July 2, 2014

SUBJECT: MEETING NOTIFICATION AND TRANSMITTAL OF TENTATIVE AGENDA

MAG Standard Specifications and Details Committee
TENTATIVE AGENDA
July 9, 2014

DETAIL NO.				REVISED	DETAIL NO.
420-2	MARICOPA ASSOCIATION of GOVERNMENTS	STANDARD DETAIL ENGLISH	PRECAST CONCRETE MANHOLE BASE	01-01-2015	420-2

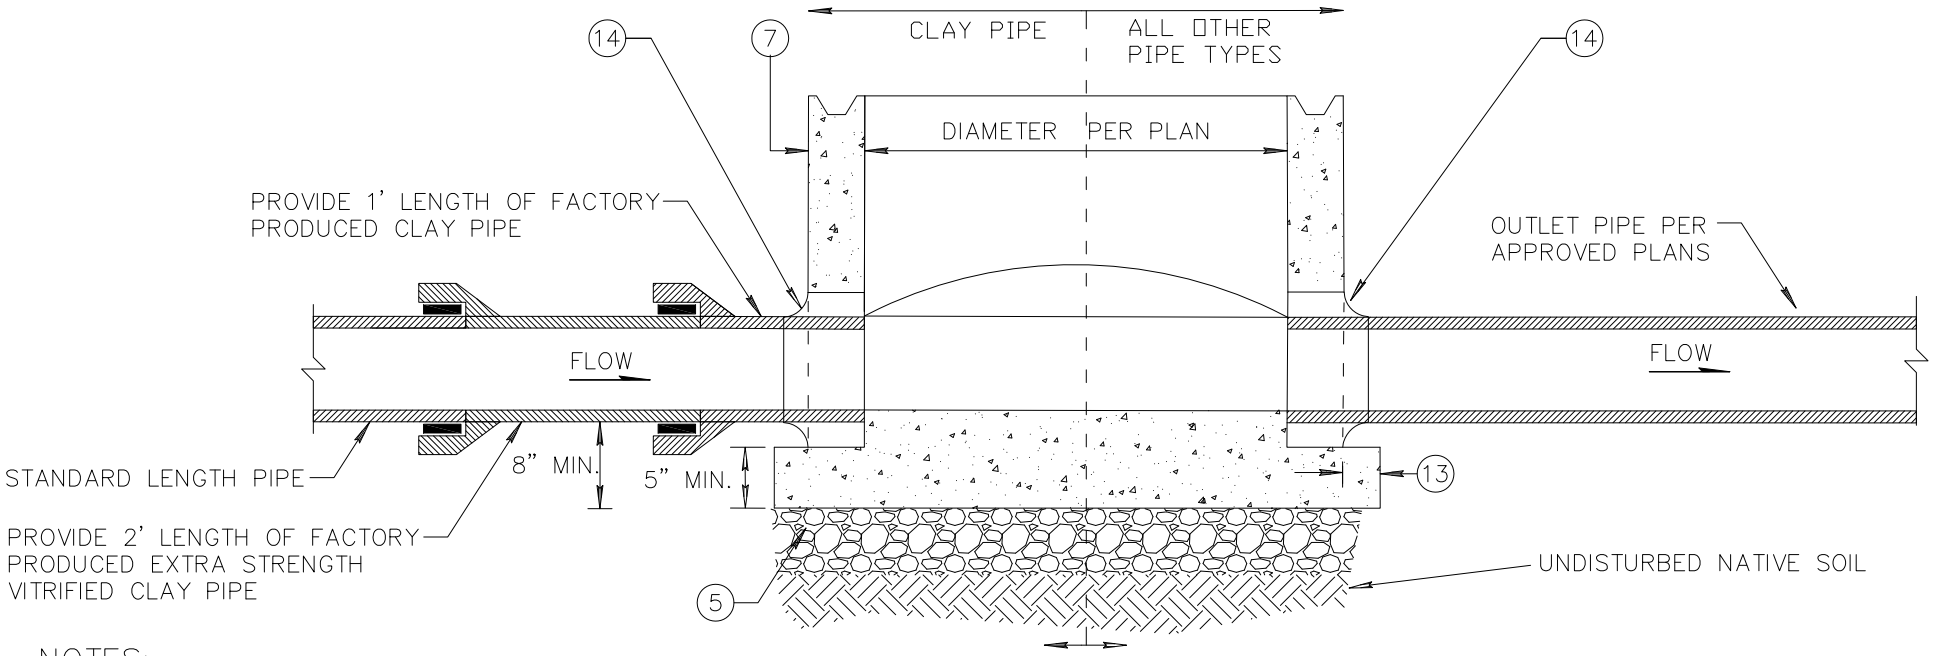
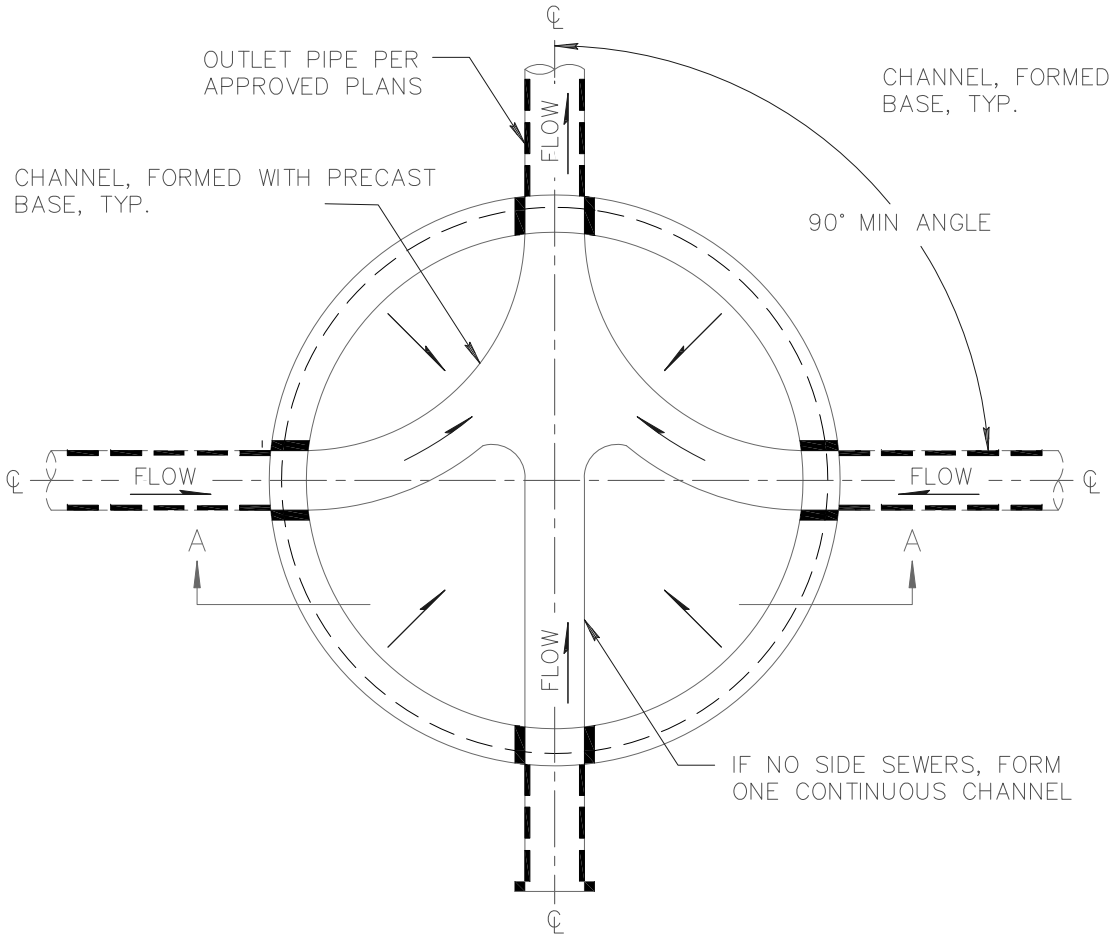
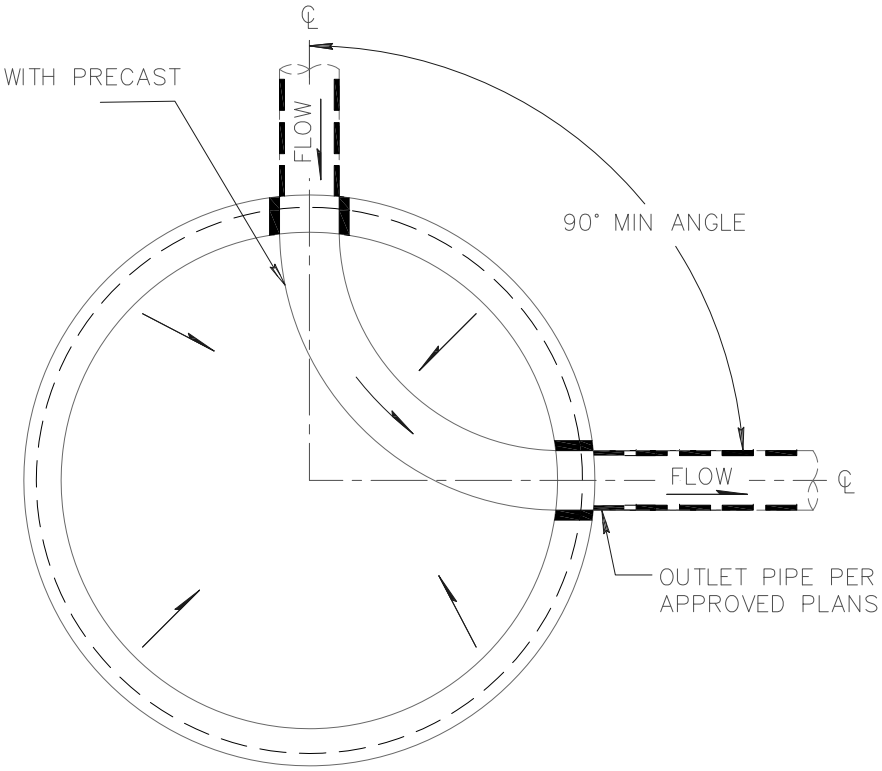
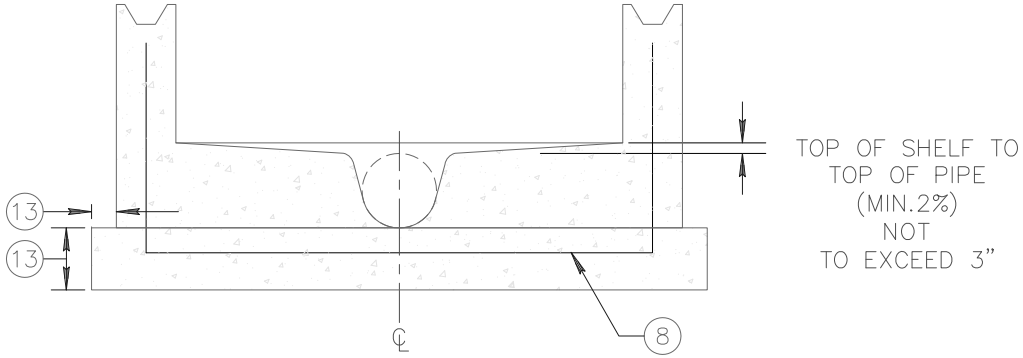
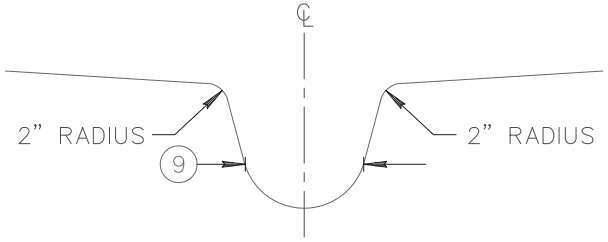
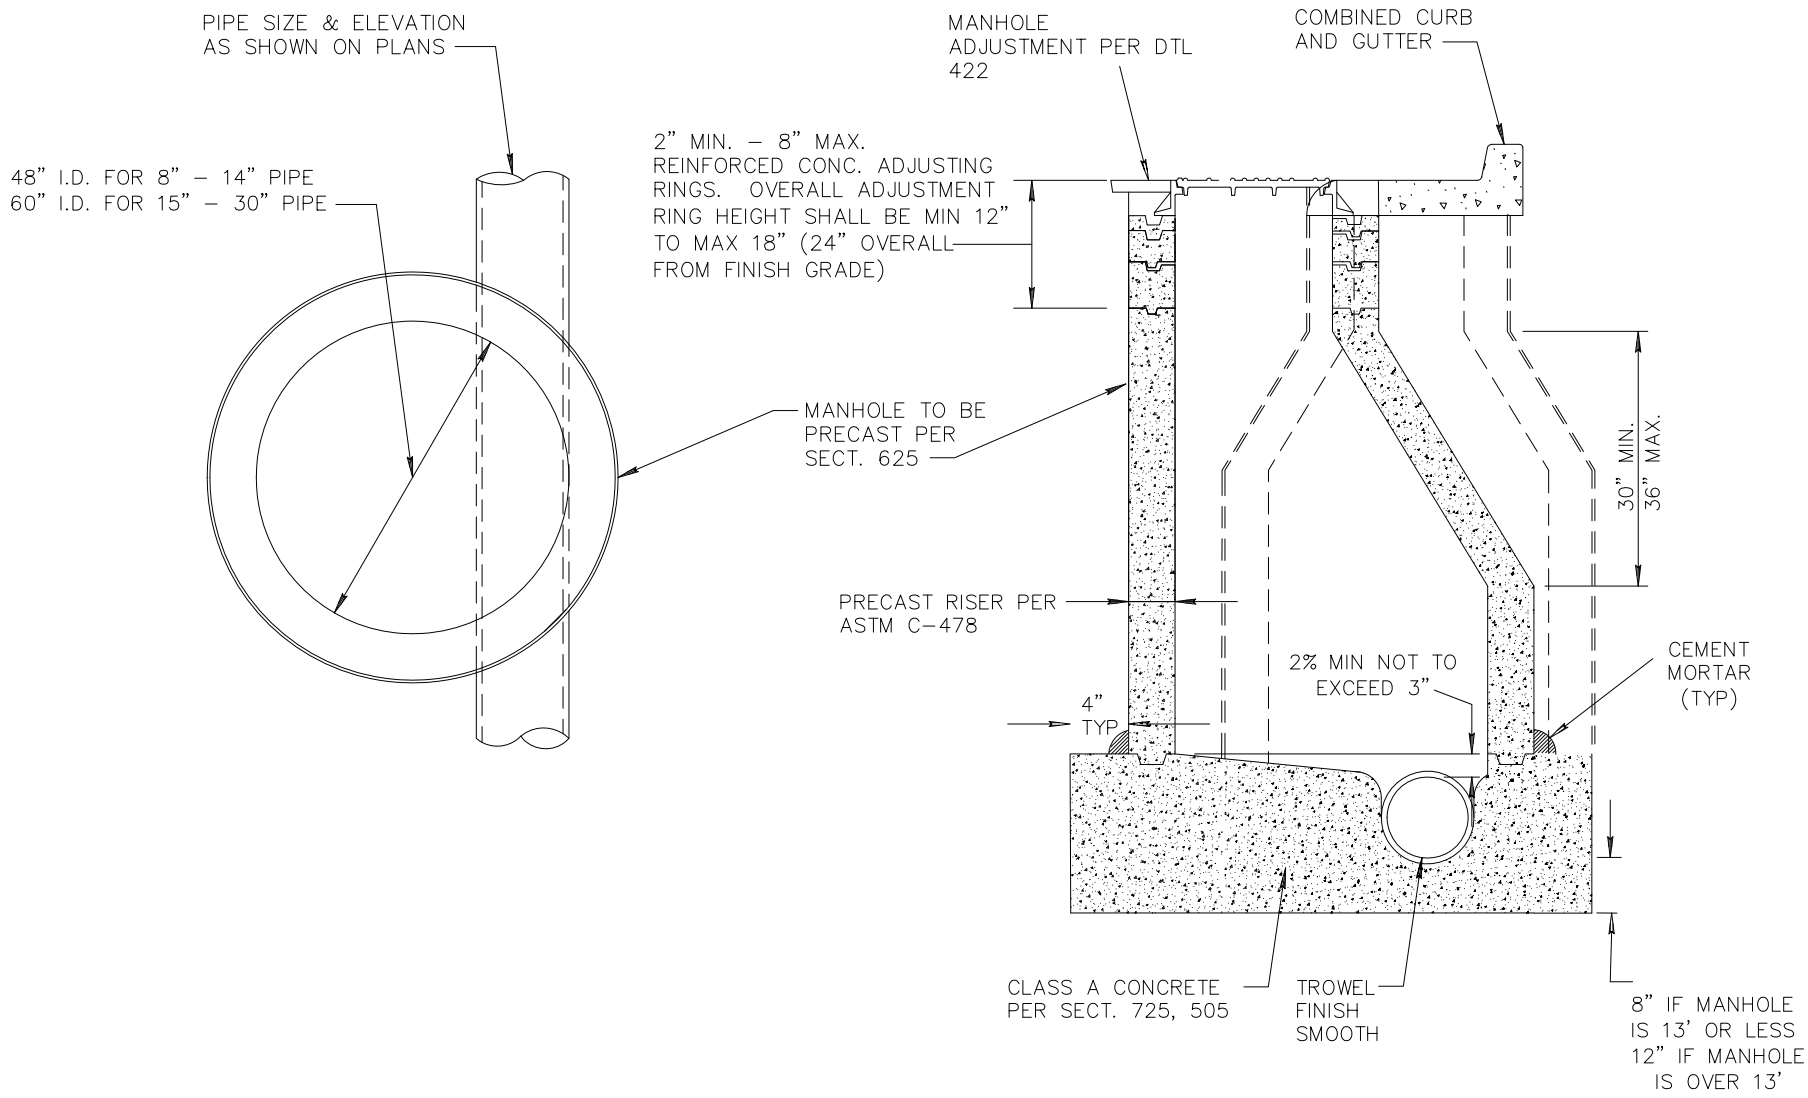
5. <u>Case 13-21: Create a new Section 742 Pre Cast Manholes. Add detail drawings for construction and installation. Update existing manhole details.</u>

Update specifications and details for pre-cast manhole bases and other corrections. An updated version of Section 742 Precast Manholes was provided in the packet. This new version changed the title of Section 742 to reflect that it provides specifications for the entire precast manhole. Craig Sharp said he changed Detail 422 to add the adjusting ring detail. He said the details were discussed during the last working group meeting and updated according to the group's recommendations. On Detail 420-2 the bell was removed from the picture and note #14 was revised. Bob Herz said that Detail 420-1 needed to show details for the cast-in-place base such as the shelf. Mr. Sharp said he could refer to Detail 420-3. Bob Shaffer found a typo in note #13 of Detail 420-2. Bob Herz said the note "medium broom finish" on Detail 422 did not need to point to the plan view. He also asked if the manhole penetration spec in Section 742 should be duplicated in Section 625 for penetrations done in the field. Mr. Herz also wondered if gaskets should be part of the construction spec. Mr. Sharp said typically gaskets are built-in at the factory, but sometimes they are added in the field, and he would review these issues. Finally Mr. Herz suggesting adding a note for the grouting around the adjustment ring and cover to make a water-tight seal.
